BID ADDENDUM NO. 2

March 30, 2026
Elmira City School District
Elementary Schools 2026 Renovations
HUNT No.: 2012-255

The following Addendum items shall be considered a part of the contract documents prepared by HUNT ENGINEERS, ARCHITECTS, LAND SURVEYORS & LANDSCAPE ARCHITECT, DPC.
Bid Document date of **December 12, 2025**; Issued For Bid **February 25, 2026**.

AD2-H1

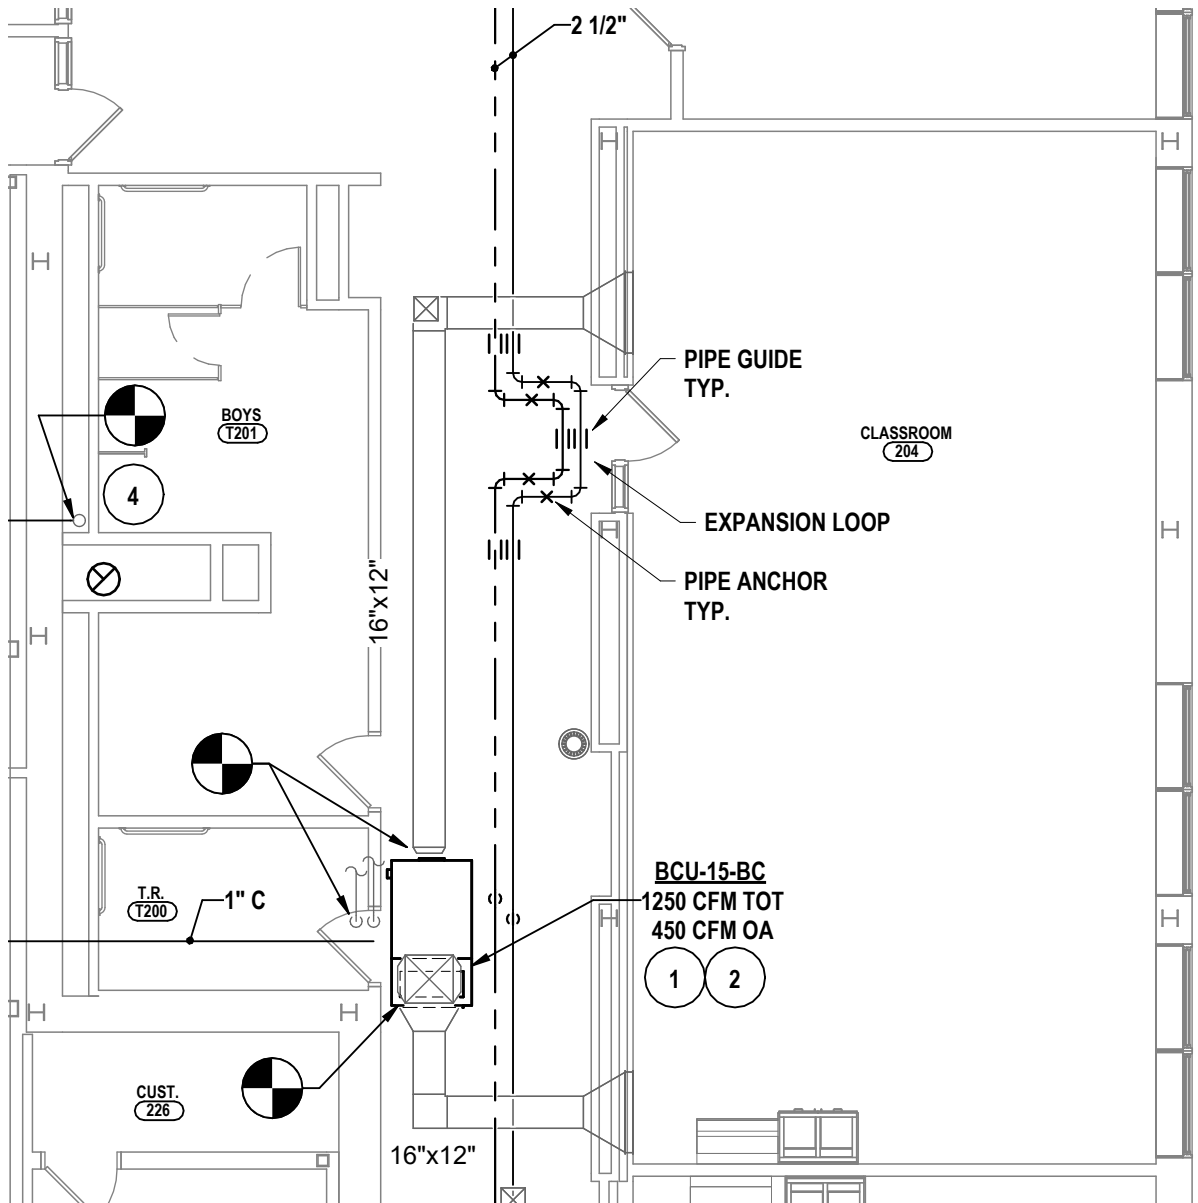
ITEM AD2-20 Refer to BC-H1.2 – CRAWL SPACE NEW WORK PLAN – AREA A

AMEND Drawing as shown AD2-H1 – BC – MODIFICATIONS TO BASEMENT PIPING – AREA A, *issued by this addendum.*

AD2-H2

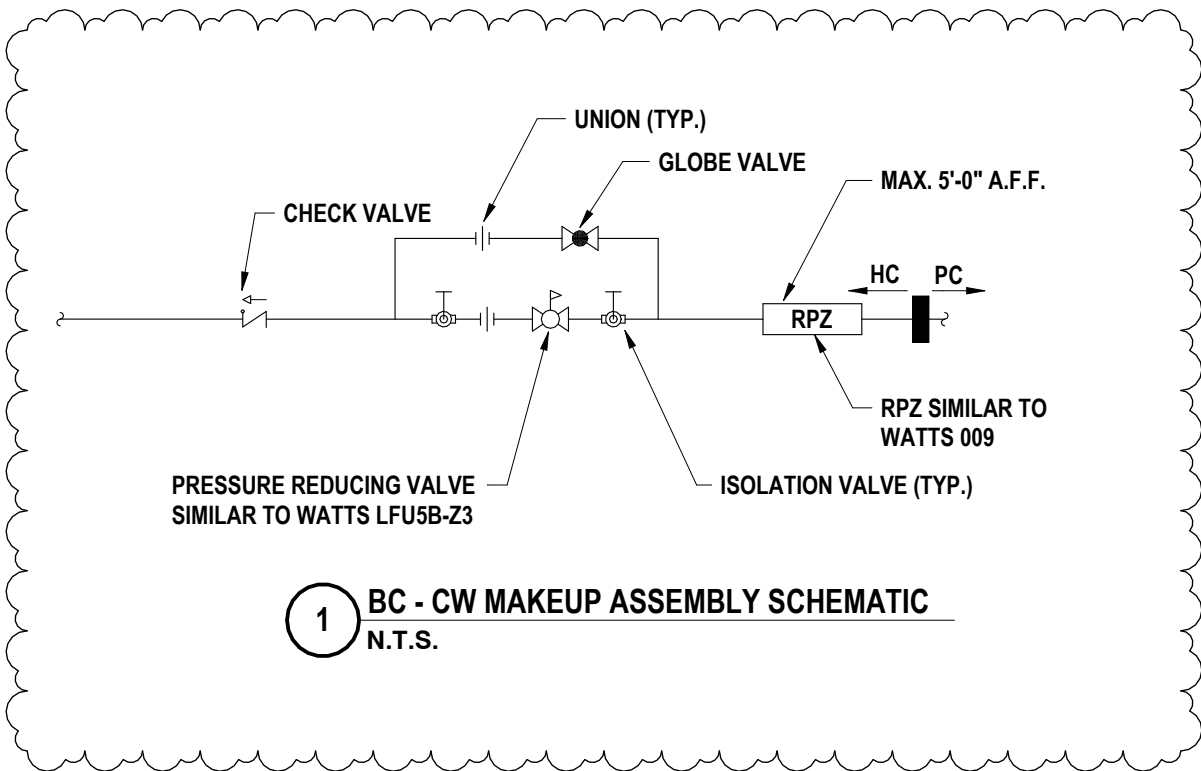
ITEM AD2-21 Refer to BC-H1.8 – SECOND FLOOR NEW WORK PLAN – AREA B

AMEND Detail 1 as shown AD2-H2 – BC – MODIFICATIONS TO 2ND FLOOR PIPING – AREA B, *issued by this addendum.*

1 FS - MODIFICATIONS TO FIRST FLOOR PIPING - AREA B
 1/8" = 1'-0"

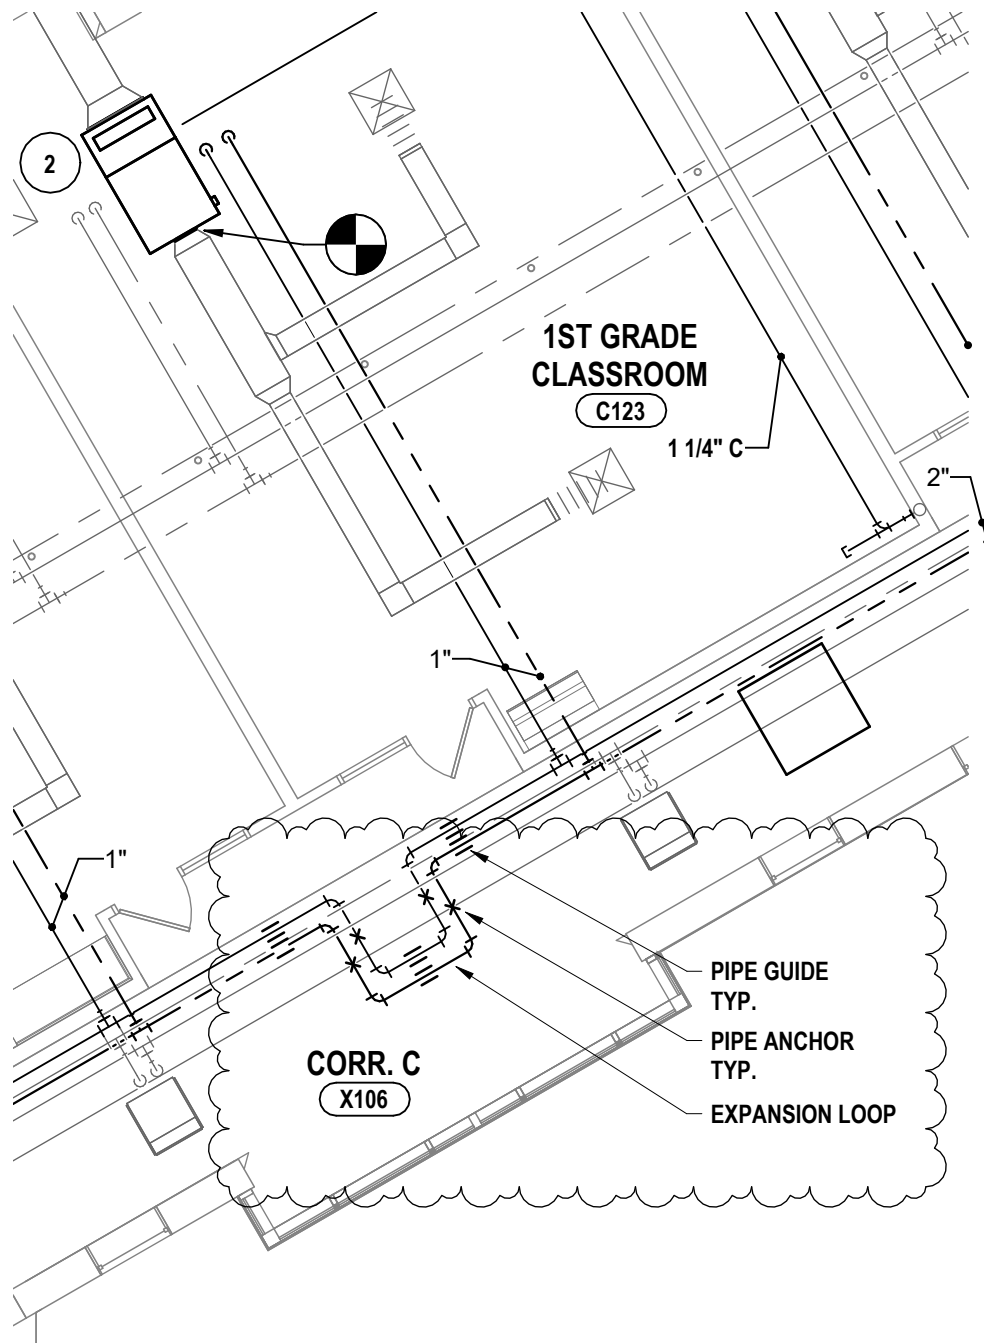
ITEM AD2-57 Refer to FS-H1.3 – FIRST FLOOR HVAC PLAN – AREA B

AMEND Drawing as shown AD2-H5 – FS - MODIFICATIONS TO FIRST FLOOR PIPING – AREA B, *issued by this addendum.*

AD2-H6

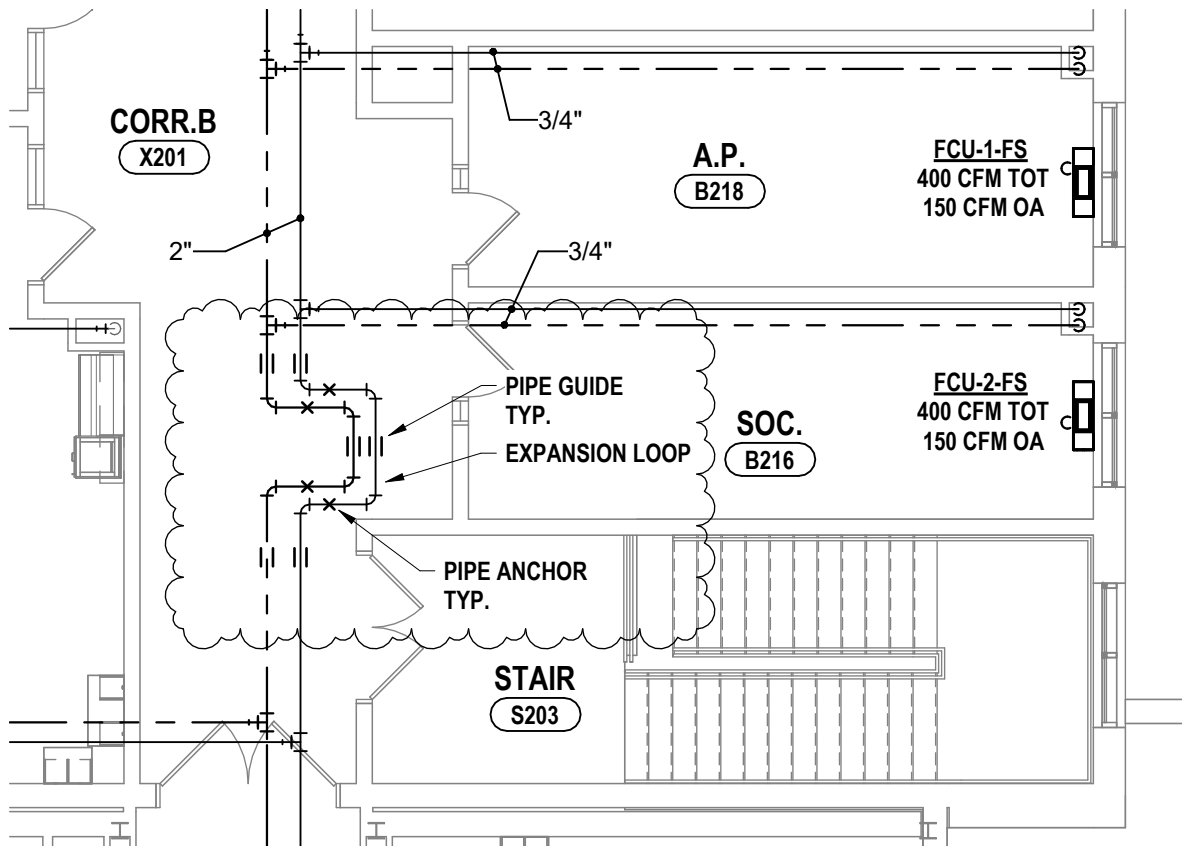
ITEM AD2-58 Refer to FS-H1.4 – FIRST FLOOR HVAC PLAN – AREA C

AMEND Drawing as shown AD2-H6 – FS - MODIFICATIONS TO FIRST FLOOR PIPING – AREA C, *issued by this addendum.*

AD2-H7

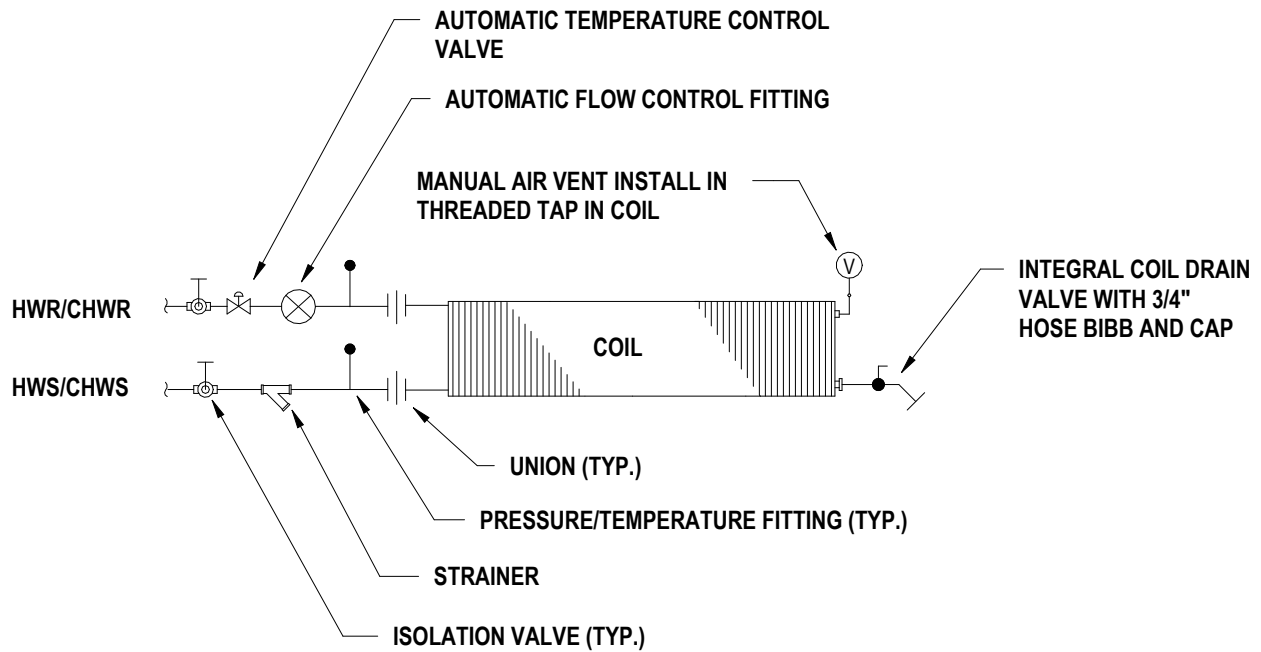
ITEM AD2-59 Refer to FS-H1.7 – SECOND FLOOR HVAC PLAN – AREA B

AMEND Drawing as shown AD2-H7 – FS - MODIFICATIONS TO SECOND FLOOR PIPING – AREA B, *issued by this addendum.*

AD2-H8
 DATE:
 03/25/26
 PROJECT NO:
 2012-255

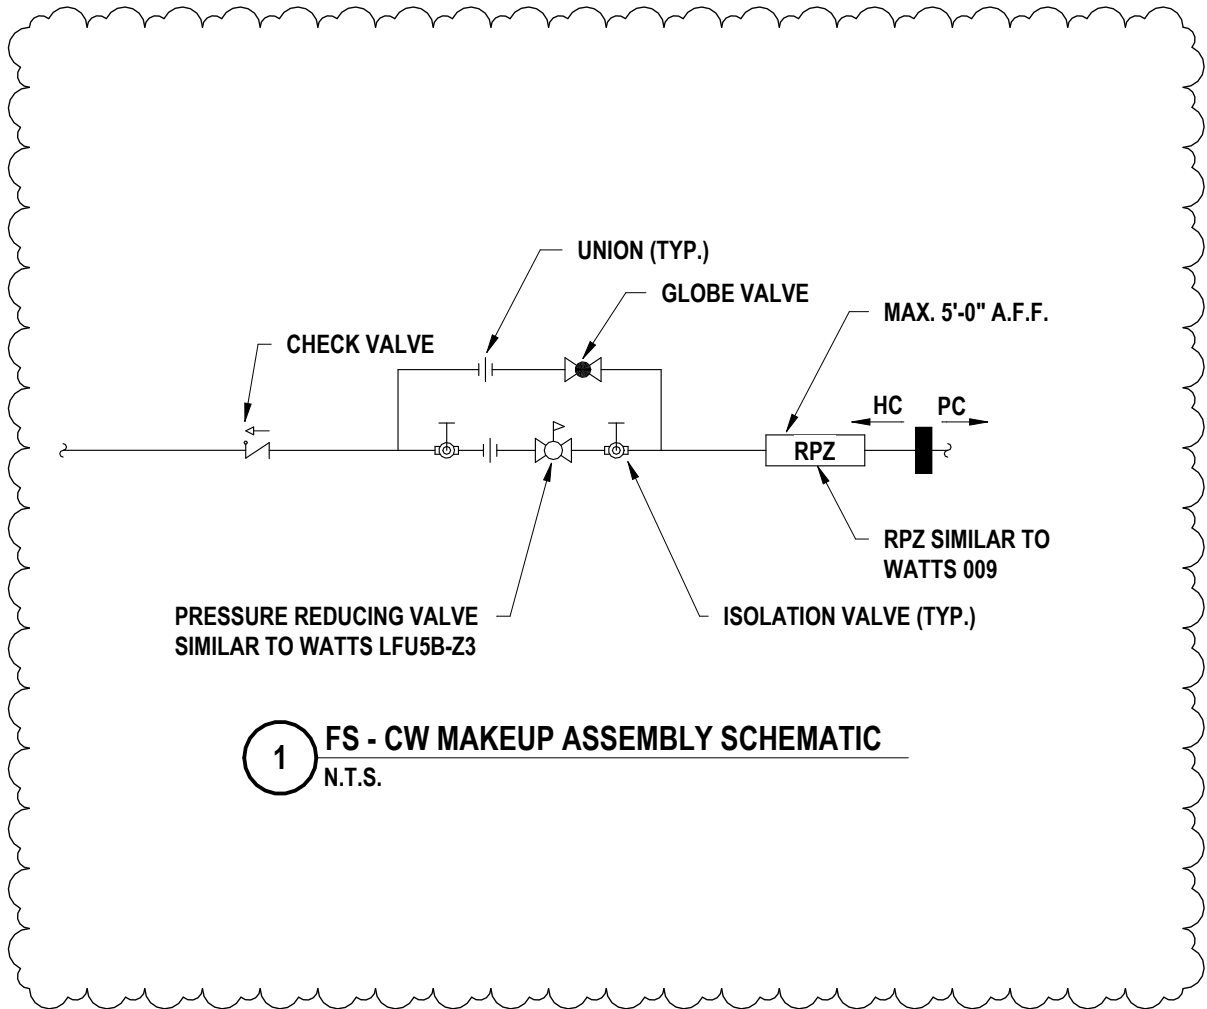
AMEND Construction Note “2” to read: “EXTEND AND RECONNECT HWS/R. PROVIDE ALL FITTINGS AND ACCESSORIES AS SHOWN ON DETAIL 3/FS-H2.1 FOR AIR HANDLERS AND AD2-H8 – FS - TYPICAL 2 WAY COIL PIPING SCHEMATIC (H&C) FOR ALL OTHER COILS.”

AMEND Detail 8 as shown on AD2-H8 – FS - TYPICAL 2 WAY COIL PIPING SCHEMATIC (H&C), *issued by this addendum.*

AD2-E1

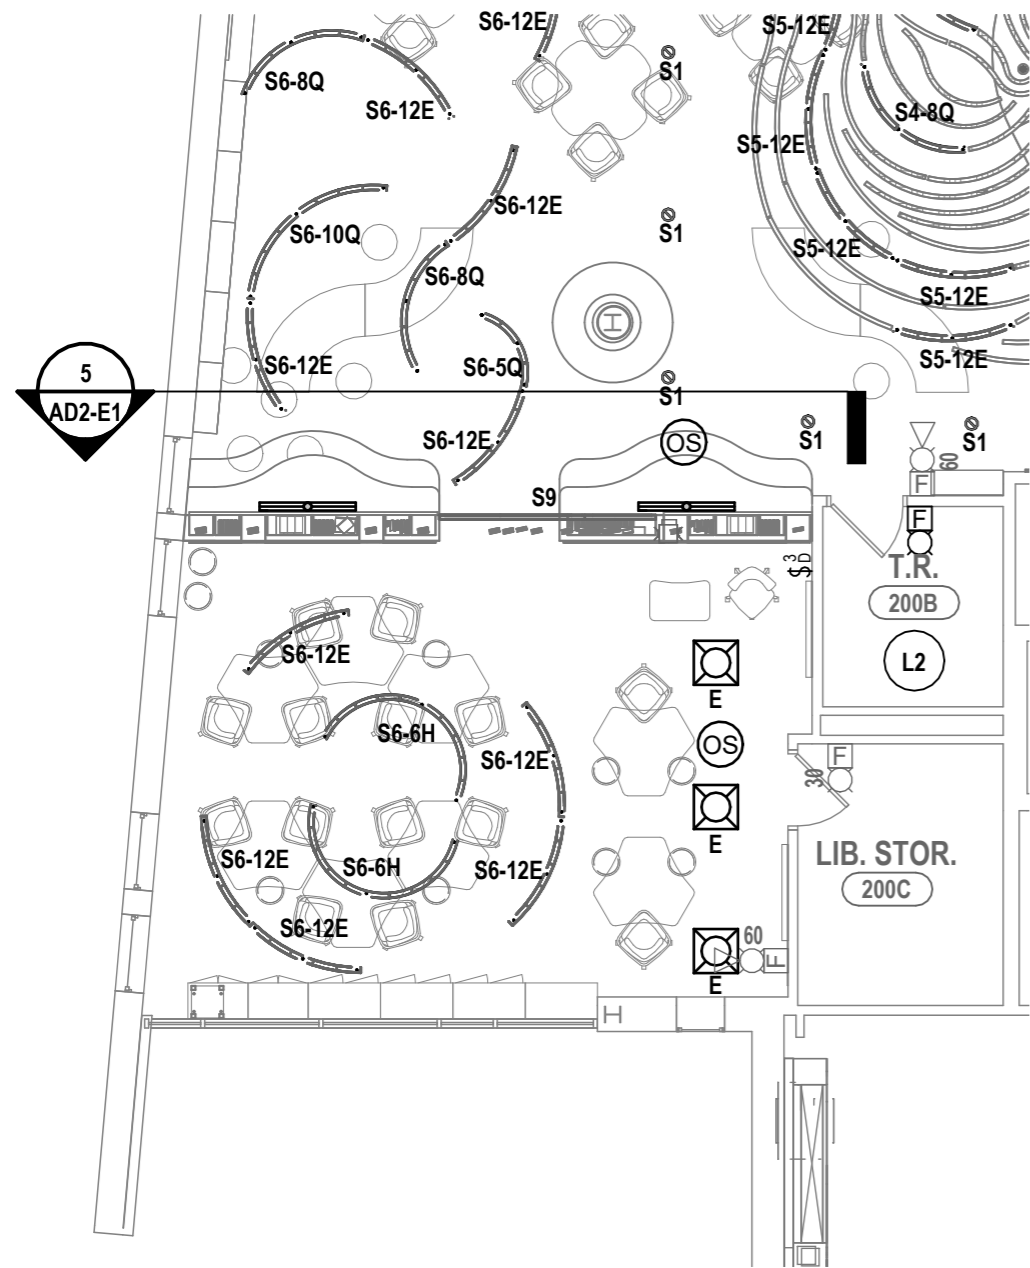
ITEM AD2-64 Refer to CB-E2.4 – SECOND FLOOR LIGHTING & FA PLAN - AREA A

ADD Details as shown on AD2-E1 - LIBRARY WALL LIGHT FIXTURES, *issued by this addendum.*
